Report on Northern Dynasty Water Rights Claims in the Pebble Mine Area

*Preliminary Analysis of Application for Water Right,
Upper Talarik Creek, Iliamna, Alaska*

Coble Geophysical Services
Over 10 Years of Service to Alaskans
10/4/06

Figure 1. Surficial Geology, Upper Talarik Salmon Biology and Schematic of Major Water Resources and Proposed Pebble Mine Diversion for the Upper Talarik Watershed (adapted from Detterman et al., 1973).

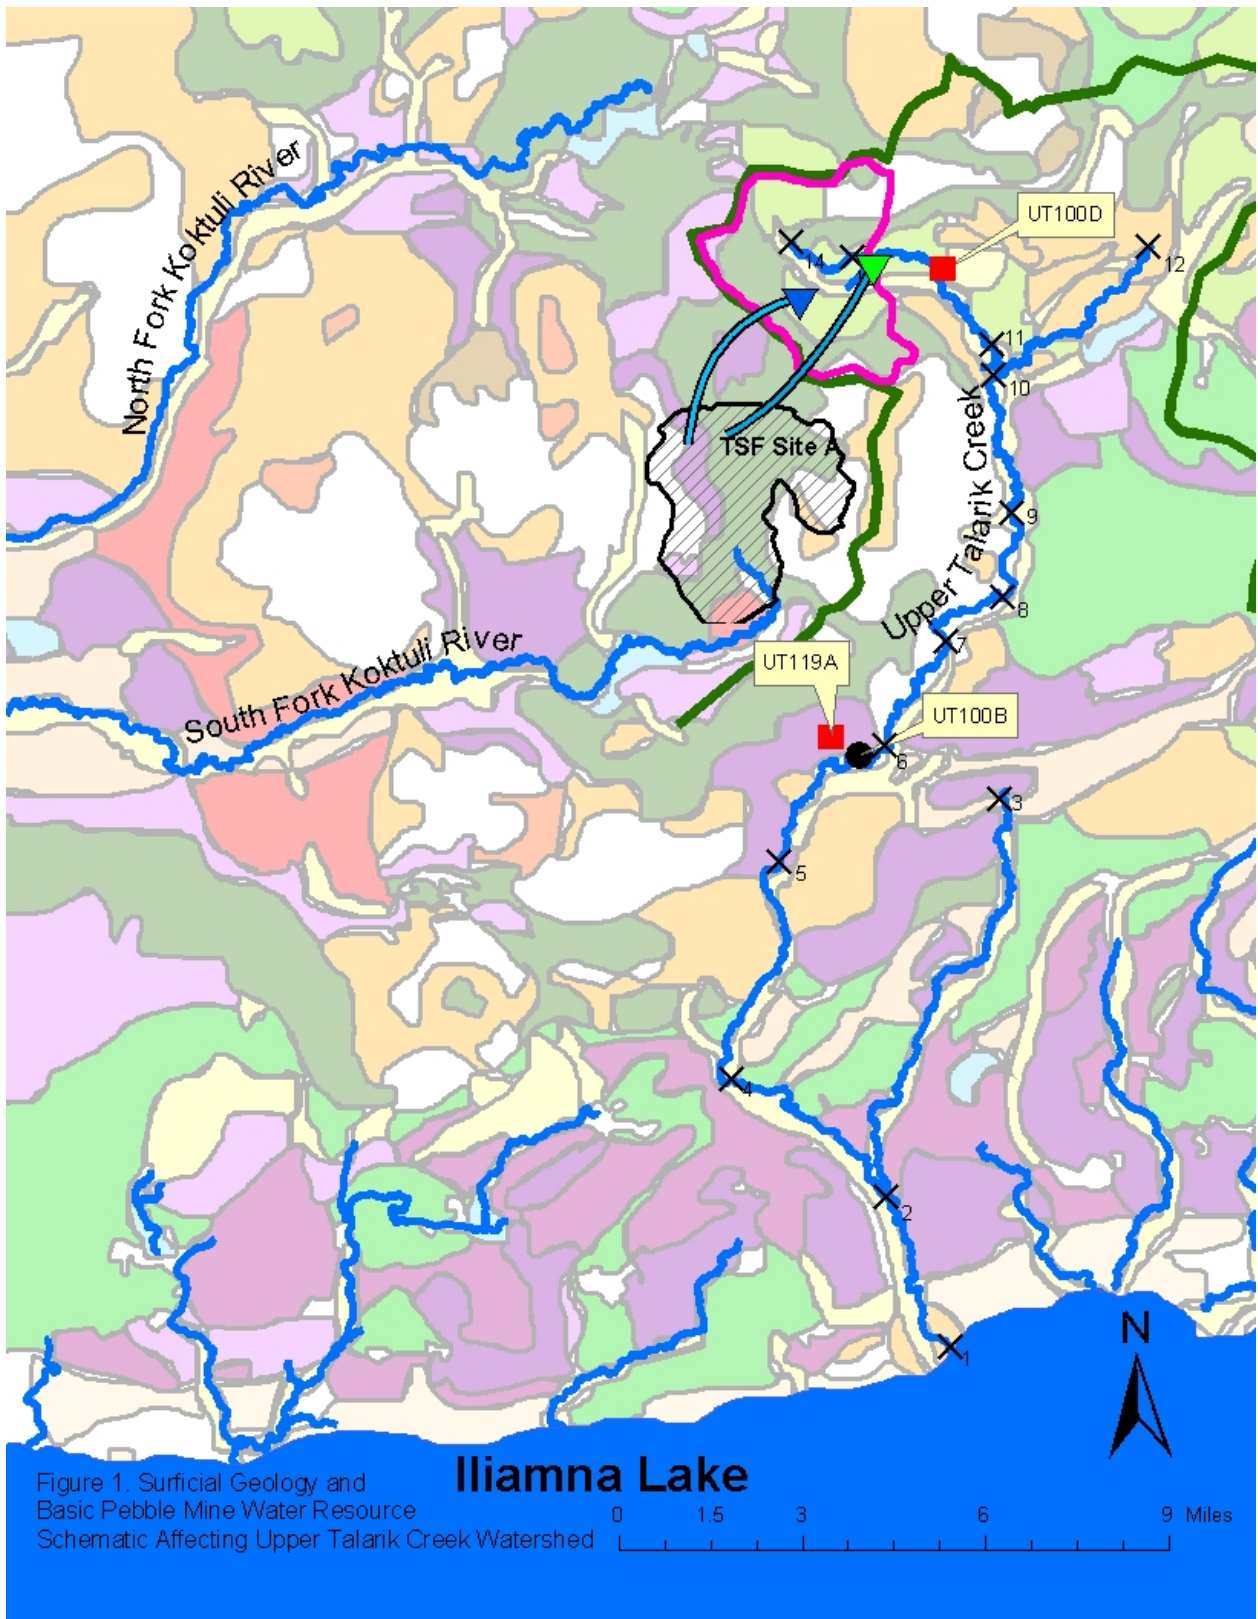
- ▶ The proposed diversions of surface water and groundwater from the Upper Talarik will create dry riverbeds in the area of DL-3, eliminating Sockeye spawning and Coho rearing habitat which exist today as shown in Figure 1.

Figure 1 shows some of the historical biologic information collected in reference to commercial salmon species, and clearly these assessments involved field work. No additional information on historic Upper Talarik Creek discharge events has been located pre-dating the NDM effort. Lack of historical discharge data is commonplace in Alaska, even for some relatively large rivers.

Figure 2. Iliamna National Resource Range Mining Claims: mineral resources, prospects, and areas geologically favorable for the occurrence of mineral deposits (USFWS, 1980).

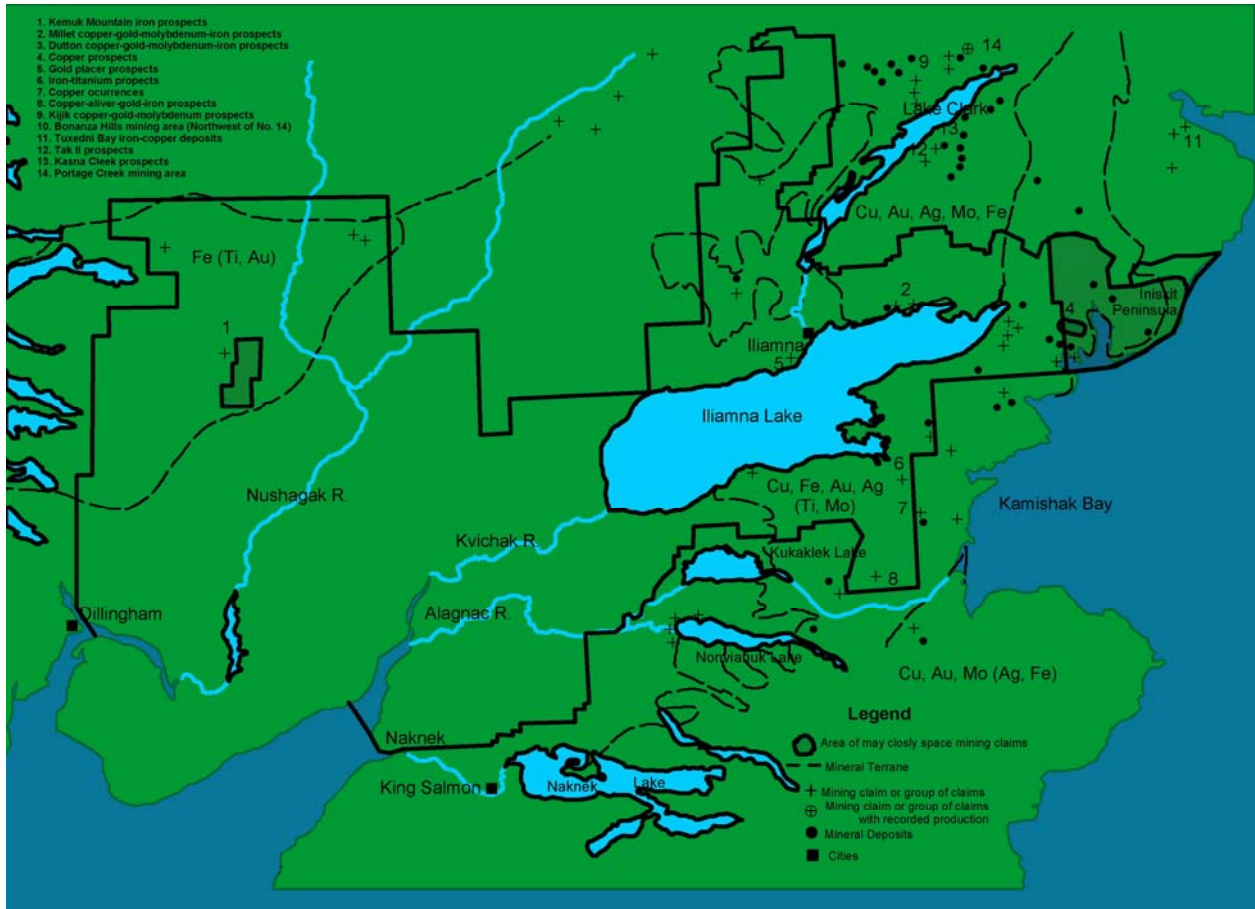
Figure 2 shows the Iliamna Lake area has a large catalog of mineral resources of over 600 square miles that have so far been recognized (from the Department of the Interior Draft Environmental Supplement, Iliamna National Resource Range, U.S. Fish and Wildlife Service, 1980), despite the area being largely unexplored. The NDM proposal could be the beginning of a long-term mining infrastructure in this area encompassing many of the resources and mining claims shown in Figure 2. The State of Alaska should evaluate the impacts to its fisheries from all projected development, perhaps including the PHABSIM modeling approach. Otherwise, any one stakeholder beginning the process could set a precedence the State will not be able to reverse later due to lack of consideration for the overall picture. This overall picture includes the cumulative effects of roads, tailings facilities, pipelines and other infrastructure for all future mining development here. The area of mineral wealth cited in the Department of the Interior paper occurs in an area of over 600 square miles.
